Additional Information: REPLACE TREE DAMAGED CARPORT, ROOF + STAIR

RESIDENTIAL PLAN CORRECTION SHEET

ADDENDUM TO Permit No. 01501-(1)
Owner MARLOW DITT
Contractor BECKER COUS
Location 203 W. MAIN

DAMAGED CARPORT RE
BY: BECK CONST. CO.
FOR: MARLOWE WITT.
JAN. 1988

SECTION A
1/2" = 1'-0"

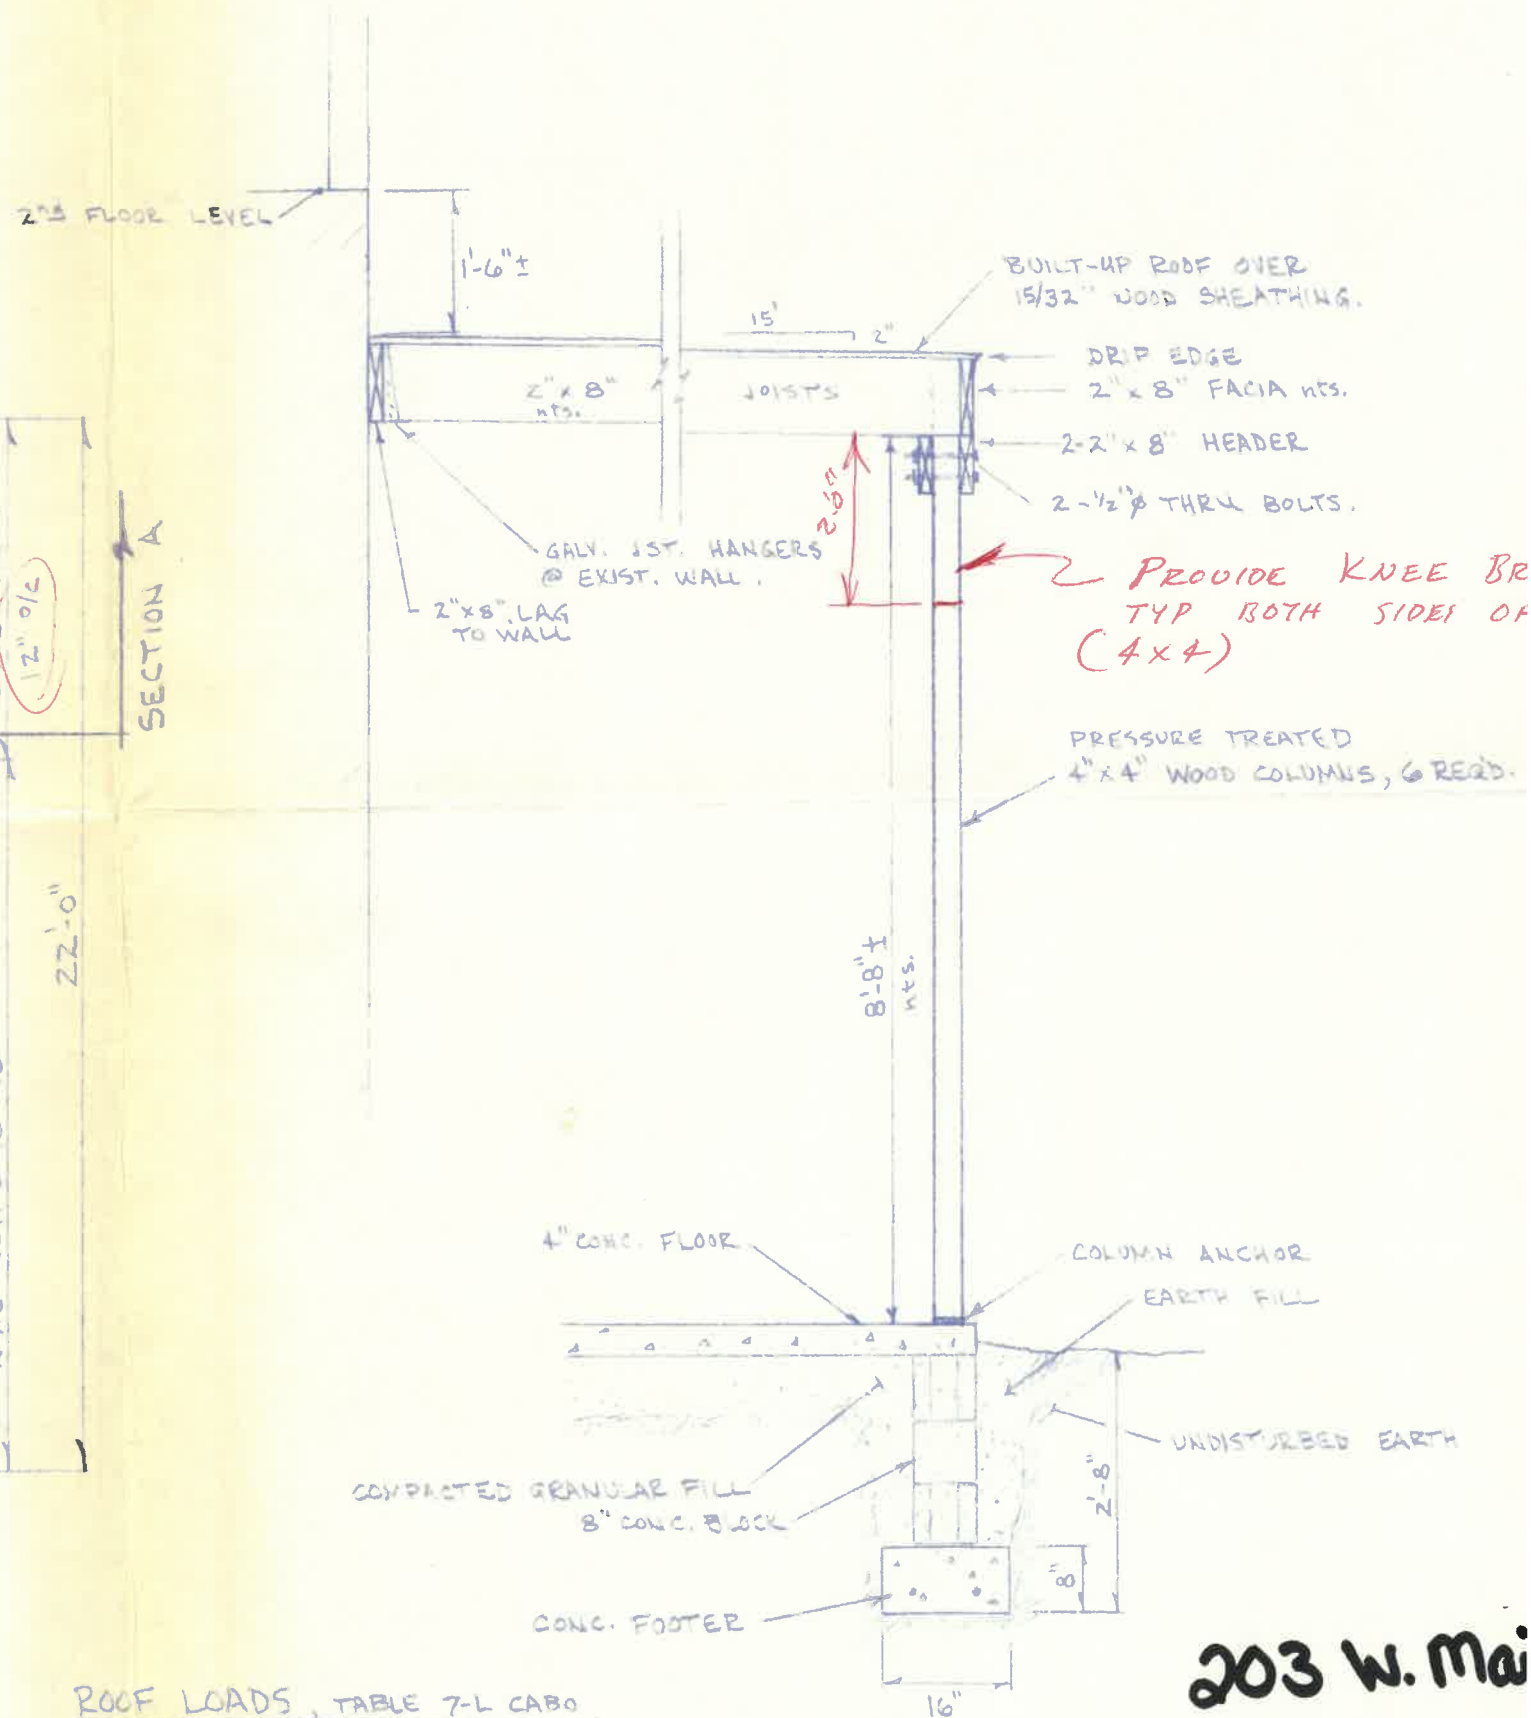
Additional Corrections. * IF THE CARPORT WALLS ARE ENCLOSED MAKING IT A GARAGE 1/2" DRYWALL WILL BE REQ. ON THE HOUSE - GARAGE OPERATION WALL ** PROVIDE KNEE BRACING AT COLUMN - HEADER CONNECTIONS *** PROVIDE APPROVED ANCHORS FOR COLUMNS

PROVIDE KNEE BR
TYP BOTH SIDES OF
(4x4)
